**From:** [PI]  
**To:** SCR CMAAllocations  
**Cc:** [PI]  
**Subject:** Road Access Location Application - 618 Tomewin Mountain Road, Currumbin Valley  
**Date:** Thursday, 9 March 2023 10:50:18 AM  
**Attachments:** [13105-230309 Road Access.pdf](#)

# Road Access Location/Road Access Works (driveway) on a State-controlled road

APPLICANT RESPONSE TO REQUEST FOR FURTHER INFORMATION - APPLICATION FOR A PERMITTED ROAD ACCESS LOCATION AND ROAD ACCESS WORKS (DRIVEWAY) - 618 TOMWIN MOUNTAIN ROAD, CURRUMBIN VALLEY

Request for further information (RFI) about application for a permitted road access location and road access works (driveway) at 618 Tomewin Mountain Road, Currumbin Valley; TMR23-038827; 29/03/2023 (copy attached)

Figure 9: IPWEA Rural Driveway Standard Detail.

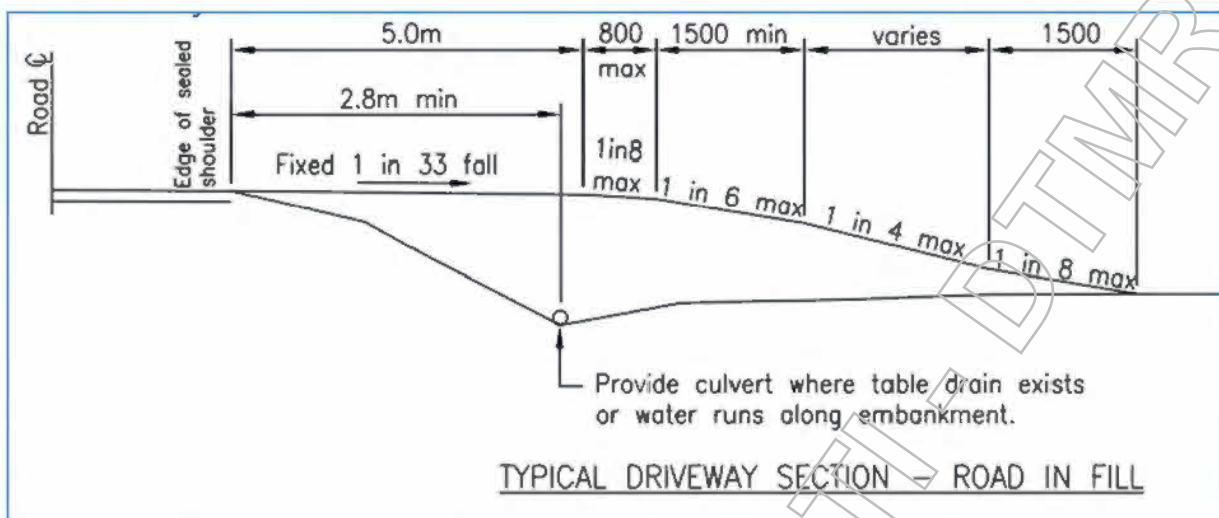
The driveway at number 628 does not provide these standard details, but the one at 618 does, thus again providing the safer access point for vehicles.

Figure 12: Proposed Access Option.

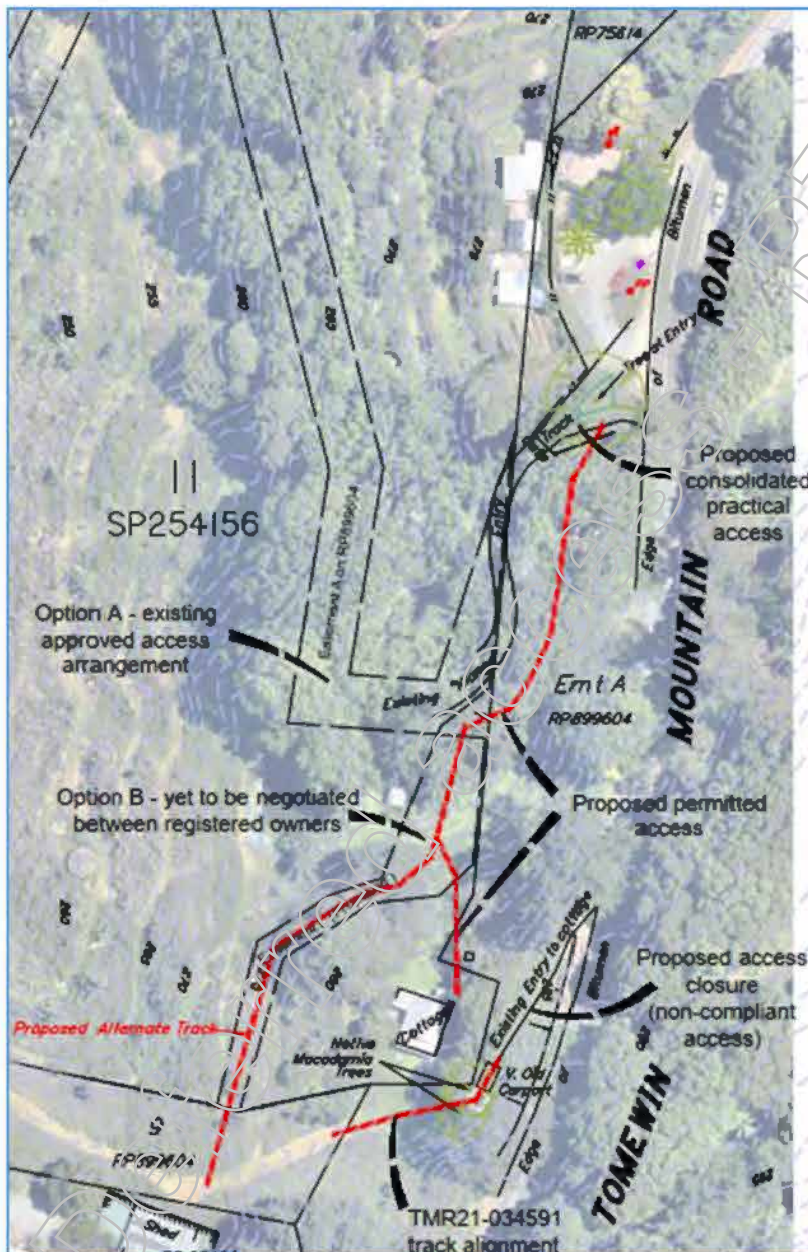
Due to the above safety issues relating to the existing access at 628, it is proposed that this access be closed and to provide an alternative access via either the existing Easement A (option A) or the proposed Easement L (option b) to exit at the same location as 618 Tomewin Mountain Road, where there is safe sight distance, a relatively flat surface, an entry angle of between 70° and 90°, and access for emergency service vehicles.

This proposal is shown in Figure 12, as a concept sketch layout. (Also enclosed with this letter).

TTM recommend that the existing cottage access be removed/closed, and a new permitted access track created to provide access the cottage and a safer access to the adjacent Lot 9.

Figure 1: Existing accesses between Lot 11 SP254156 and Tomewin Mountain Road (TMR) (source: Existing Site Features Layout Plan, Pacific Civil Engineers, PCE-23-010 Dwg 002 Rev B)

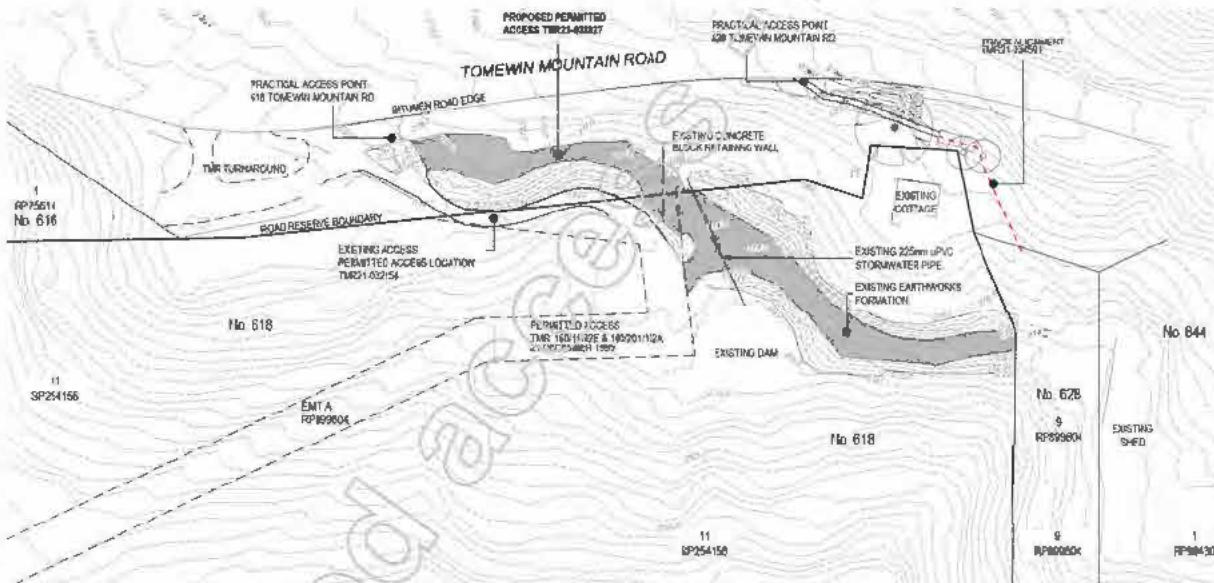
Please provide a plan of development illustrating any and all other existing or proposed vehicular accesses to the land to/from the State-controlled road corridor. The department notes there are at least one (1) other vehicular access to the land which is not be regularised and recognised with an approval.

Refer to Figure 1. The figure includes existing permitted and practical access points along the frontage of the subject site (approx. 180m). Note that pedestrian access is also gained between the TMR turnaround PI (not indicated). We are not aware of any further unformalised vehicular accesses between the site and Tomewin Mountain Road. However, this can be addressed upon specific advice from TMR.

FIGURE 2: SITE TRAFFIC MANAGEMENT

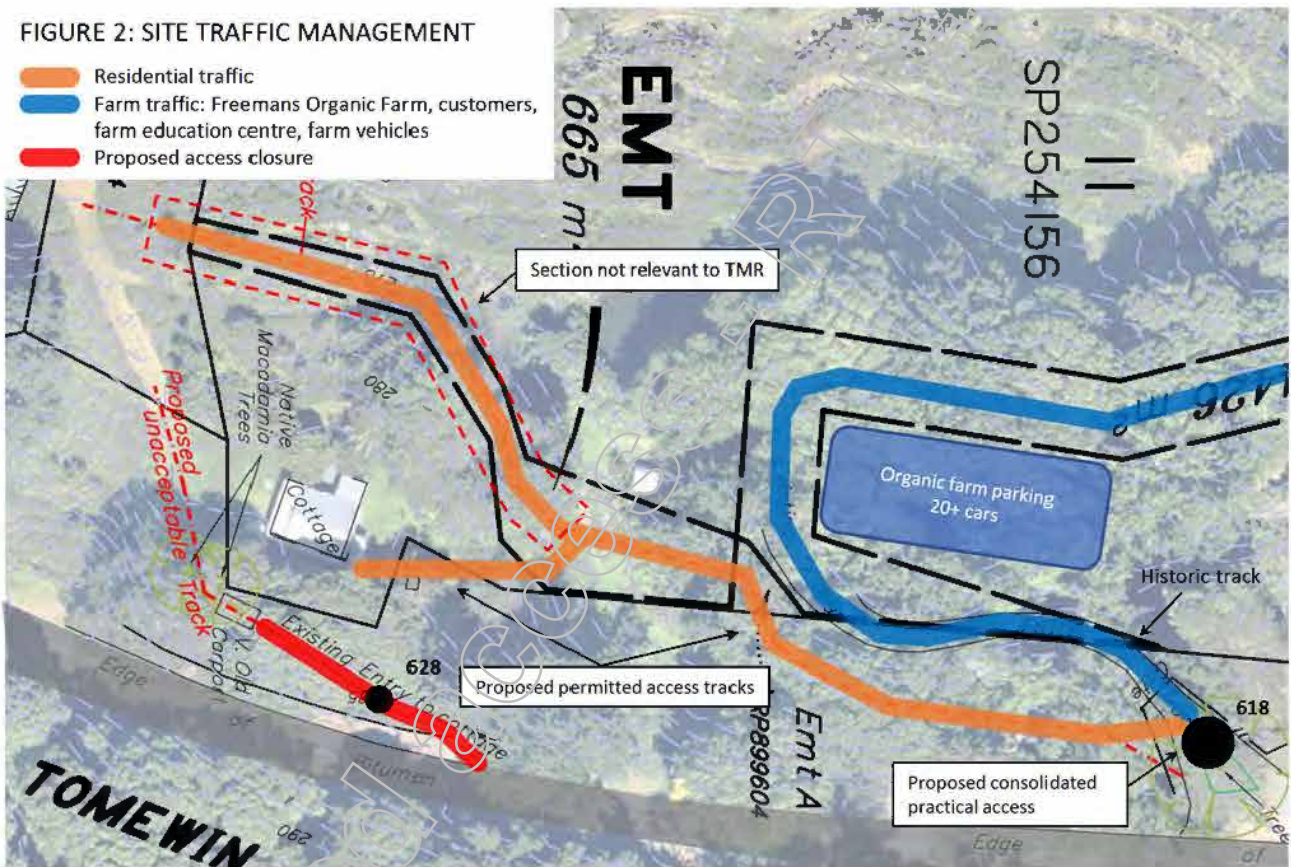
- Presented "Figure 2 Site Traffic Management Rev 1 19/04/2023" demonstrating a key purpose of the application being to separate residential traffic from non-residential traffic, thereby significantly improving the safety and efficiency of both site traffic and the state transport corridor (Rev 2 figure attached, amended to reflect meeting discussions) (See Attachment 2.)

- Acknowledged that the site traffic management figure rationalises practical access points to the SCR for 618 Tomewin Mountain Road which is supported by TMR. (MT)

- The meeting then discussed the individual RFI items:
  1. Purpose – MT agreed that the tabled Site Traffic Management figure addresses this point.
  2. Amended Plan of Development – applicant to prepare per the meeting discussions.

N.B. Rev 2 figure reflects meeting on 20/04/2023
